Subject: McGuire Nuclear Station, Unit 1
Docket No. 50-369
ASME Code Section XI Requirements
Relief Request No. 88-01

McGUIRE NUCLEAR STATION RELIEF REQUEST NO. 88-01

REQUEST FOR RELIEF FROM ASME CODE SECTION XI
REQUIREMENT DETERMINED TO BE IMPRACTICAL

FABRICATION SKETCH

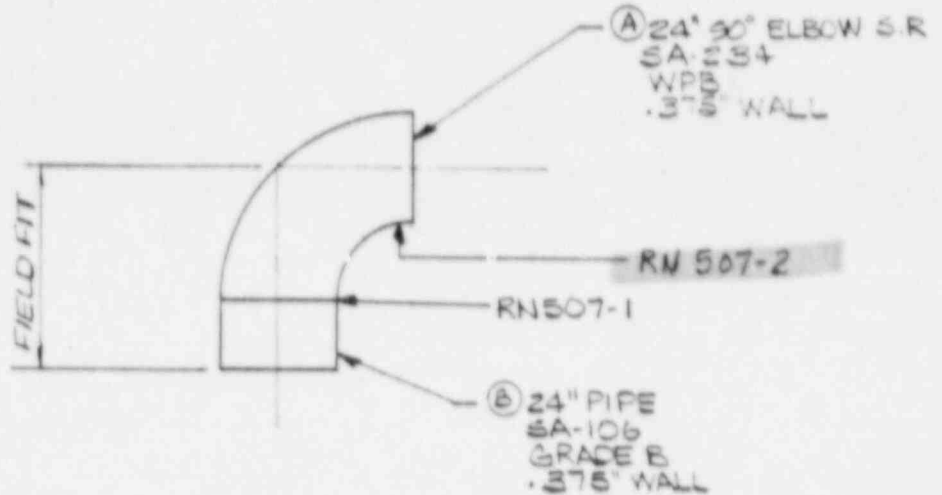
DUKE POWER COMPANY CONSTRUCTION DEPARTMENT PROJECT <u>MC SUIRE</u>	
						TITLE	
						SYSTEM RN DWG. MC-2418-14.41-02 MFI-1RN 57	
1		ADDED WELD 507-2 FOR CORRECTION OF HOLE IN PIPE - DTD W R 133867		L-202 L-203		3 7	
0		REL. FOR CONSTRUCTION		NAW LPT B-575 5-375		MUB E-575 5-375	
NO.	REMARKS	ORIGD	CHRD	MECH	WELD	QA	REV NO.
		DATE	DATE	DATE	DATE	DATE	1
						SUBASSEMBLY NUMBER	
						RN507

EXPLODED VIEW

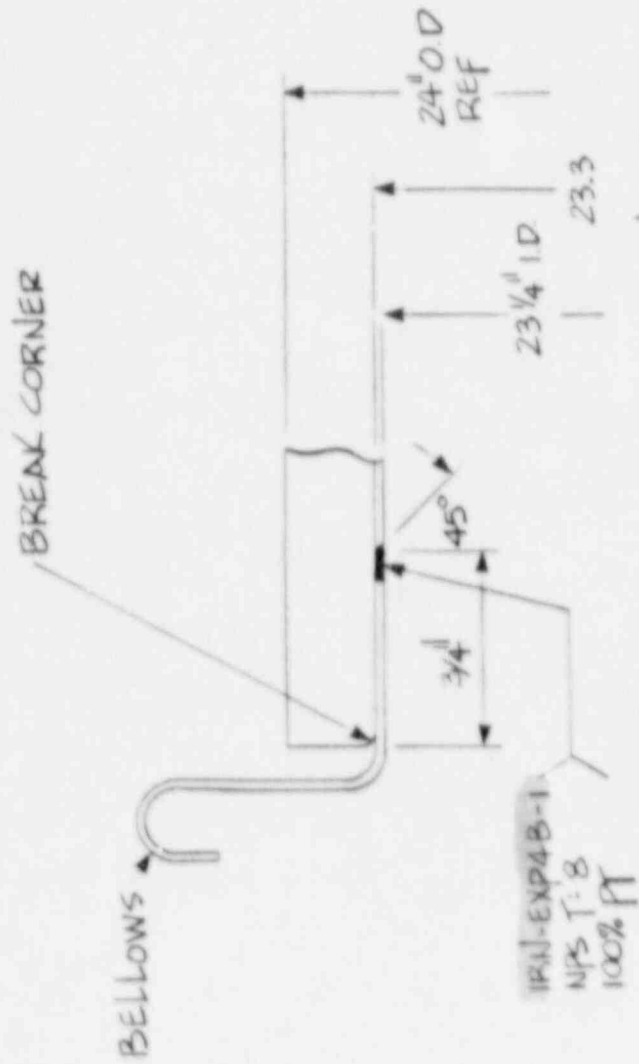
SEAL WELD REPAIR IS APPROX. 6" LONG
